AGENDA
Design Review Committee
November 10, 2021 – REGULAR MEETING
5:00 PM

2. CALL TO ORDER
3. ROLL CALL
4. NEW BUSINESS
 - I. P21-082: 105 E Broadway Conceptual Review (Continuation) - King of Broadway
5. MATTERS FROM STAFF
6. ADJOURNMENT

Name/Description: KING OF BROADWAY Multi-Use Building
Physical Address: 105 East Broadway
Lot, Subdivision: PT. SW1/4SW1/4, SEC. 27, TWP. 41, RNG. 116 PIDN: 22-41-16-27-3-00-012

DRC NARRATIVE

⑤ FRONT FACADE
1/4" = 1'-0"

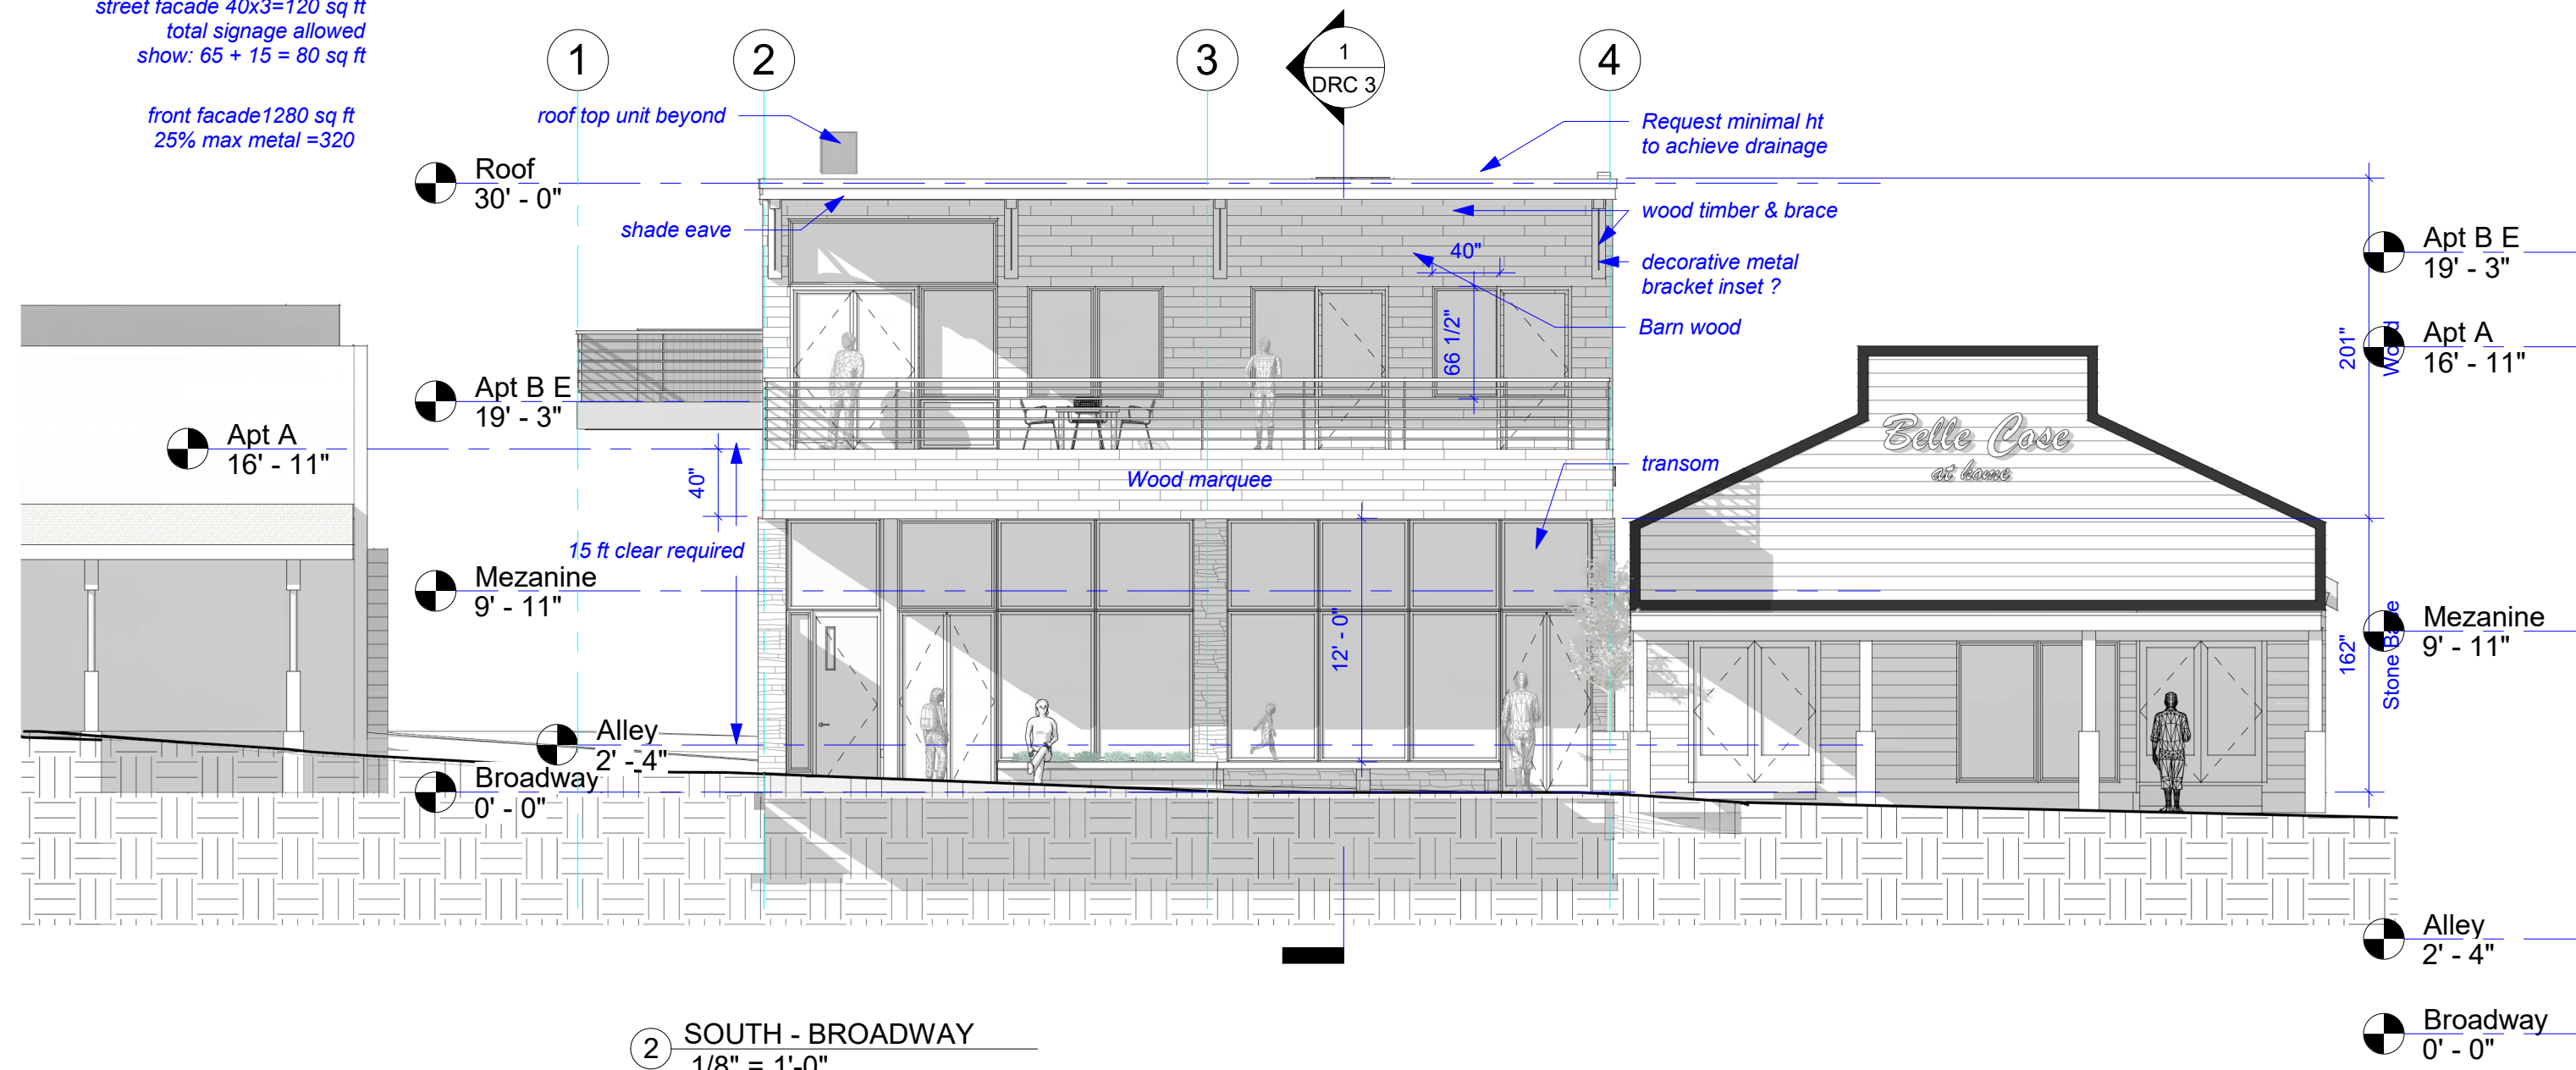
Solid wall above window heads increased.

Accent glazing at upper SW corner encouraged by LDR 1.21 page 27. Captures view toward Snow King at terminus of King Street

Apt A Dropped 28" with internal ramp, lowering Broadway Balcony

Balcony Roof detailed as robust cornice with timber & metal supports

Windows expressed as punched into wall, especially at upper level

Duplex approach abandoned. Wood over Stone both sides

Marquee in same wood as upper cladding helps proportions approach 1/3 base, 2/3 top. Thickness reduced.

Metal cladding revised to stone bench & planter in wood

Lower level Glazing width reduced for pedestrian scale
